Historic Architectural Review Commission Staff Report for Item 15

То:	Chairman Haven Burkee and Historic Architectural Review Commission Members
From:	Daniela Salume, MFA Historic Architectural Preservationist
Meeting Date:	May 27, 2025
Applicant:	Richard J. McChesney
Application Number:	C2025-0041
Address:	620 Dey Street

After the fact - Demolition of historic accessory structure in rear of property and removal of existing fence.

Photo of property under review.

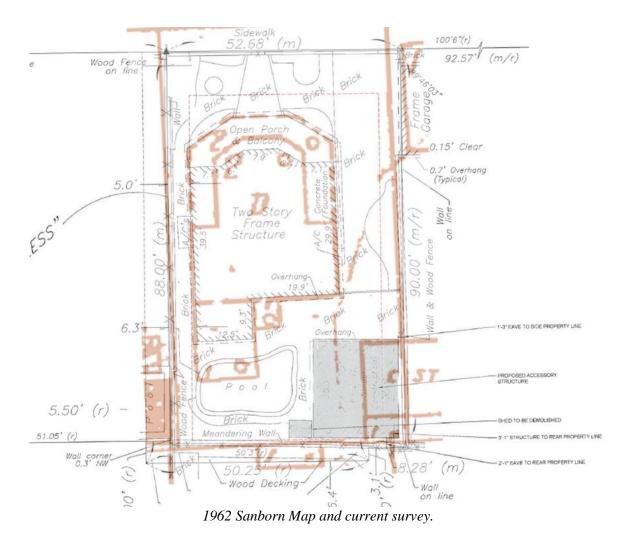
Elements proposed for demolition are historic, however, the structure had toxic black mold as seen on the photos provided.

It is staff's opinion that the request for after-the-fact demolition may be considered, as the structures under review meet the criteria for demolition outlined in the guidelines. Specifically, the accessory structure was reported to contain toxic black mold, and photographs submitted by the applicant support the claim of hazardous interior conditions. However, staff emphasizes that demolition of a historic accessory structure, regardless of condition, should not have occurred without prior permits or approval. That said, the Commission can consider the application based on the facts presented and the condition of the structure at the time of removal. If approved, this will be the only required reading for demolition. Staff will review submitted construction plans for demolition and design to ensure consistency with submitted drawings.

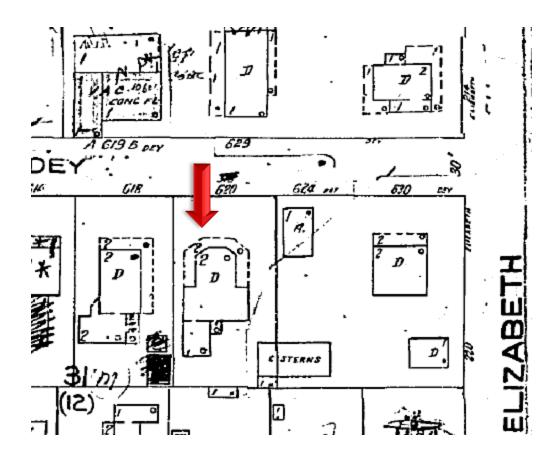
Although historic by age, the accessory structure is not original to the primary home. As far as the relationship between the primary

residence and the accessory structure, the new building replaces it within the same footprint.

The fence is not historic.
